Review of CalAC and CalME empirical overlay design

Document created by: Rongzong Wu (rzwu@ucdavis.edu)

Document created: 12/21/2018

Figure 17. Increase of GE needed with mill depth

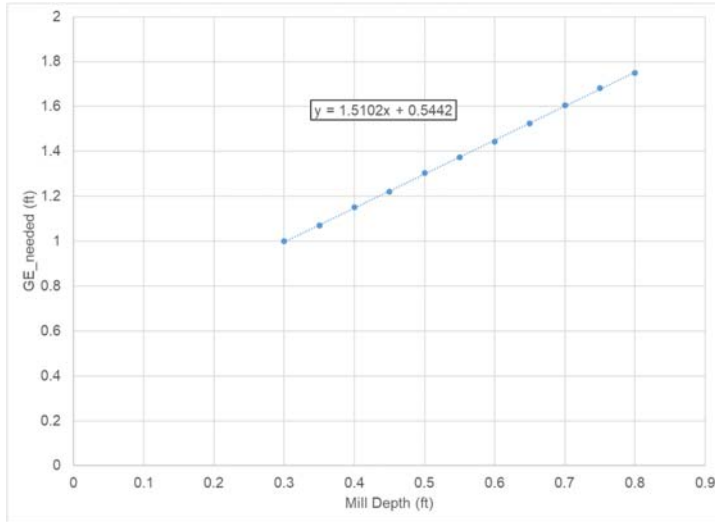
Figure 16 shows the remove and replace options for a pavement with 0.30 ft HMA/0.50 ft CTB/1.0 ft ASB. The GE needed can be back-calculated as:

The correlation between GE needed and mill depth is shown in Figure 17, which indicated that for every foot of CTB milled, GE needed increases by 1.51 ft. This implies a Gf of 1.51 was used for the removed CTB. After accounting for rounding error, a value of 1.50 was likely to have been used as Gf for the removed CTB. This is roughly equal to the average of Gf for CTB-A (1.7) and CTB-B (1.2).

Figure 18. Correlation between GE needed and mill depth for 0.3 ft HMA/1.0 ft PCC (with and without crack and seat)

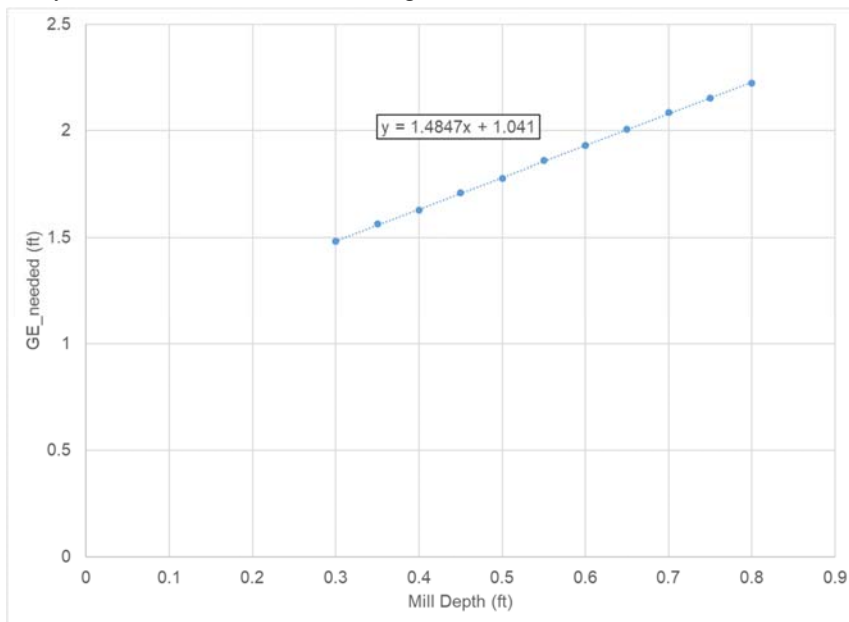
Using the same approach shown in Section 3.3.3, the Gf for removed PCC layer can be back-calculated to be 1.49 (See Figure 18). After accounting for the rounding error, a value of 1.50 was likely used for Gf of removed PCC regardless of whether it was crack and seated.

Figure 23. Mill and overlay with CIPR option from CalAC

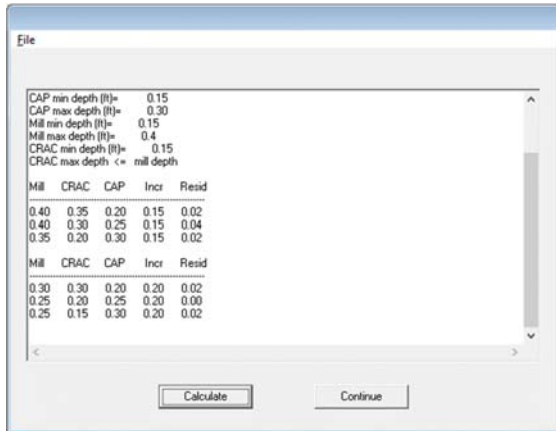
The design example tried different mill depth to find one that satisfy the 0.10 ft minimum grade reduction requirement (compared to basic overlay). The recommendation is mill 0.30 ft /0.30 ft CIPR / 0.20 ft HMA as cap. CalAC on the other hand, presents many more options (see Figure 23).

Figure 25. Hot recycling options from CalAC for Example 6

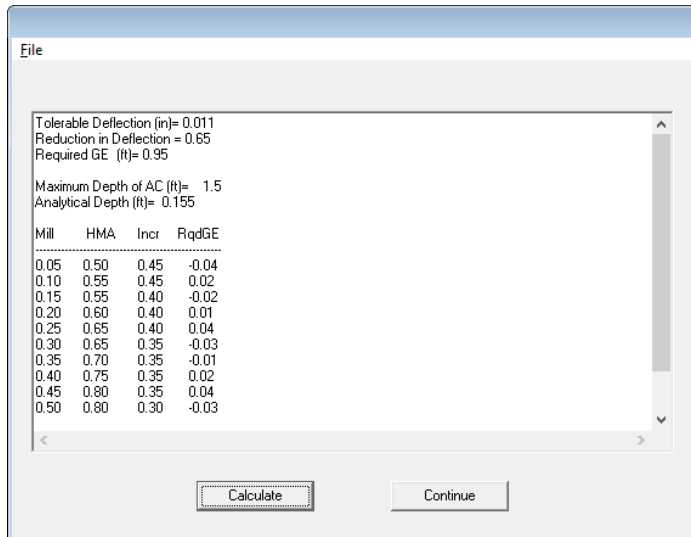
As shown in the table, the only difference is for the 0.05 ft milling option. Based on Figure 25, the GE needed is $1.9 \times 0.50 - (-0.04) = 0.99$ ft, which correspond to the 1.0 ft needed for 67% PRD after account for the rounding error. The HMA thickness needed is then $1.0/1.9 = 0.526$ ft so should be rounded to 0.55 ft rather than 0.50 ft.

Figure 27. Partial remove and replace options from CalAC for Example 7

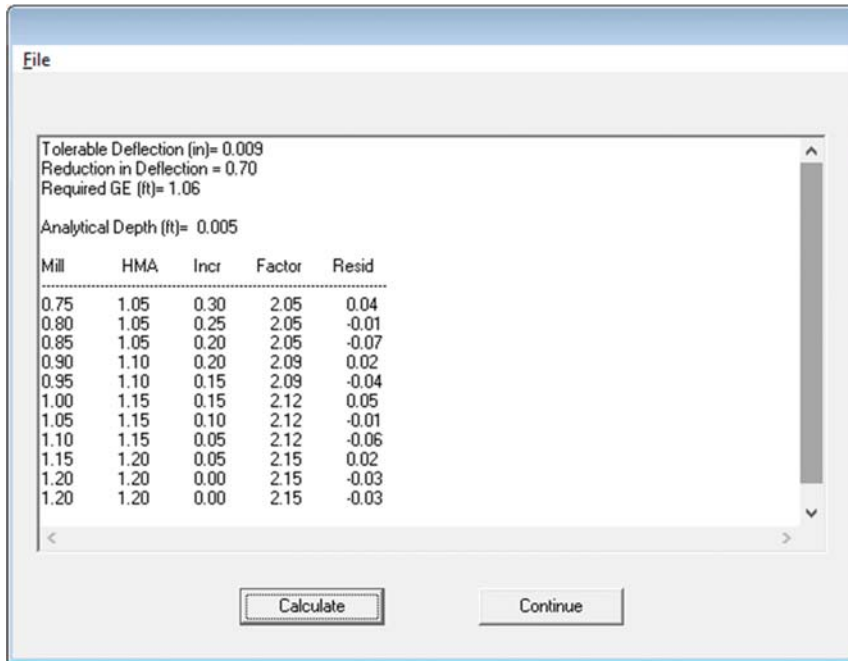
As shown in Table 4.7, there are some slight difference between CalAC and CalME. This is likely due to the error in analytical depth calculation for CalAC. In particular, the analytical depth should be zero in this case, but CalAC arrives at 0.005 as shown in Figure 27. Higher analytical depth means less overall GE required for the removed existing HMA layer because the GE needed to replace the removed HMA down to analytical depth is fixed by the 70% PRD.
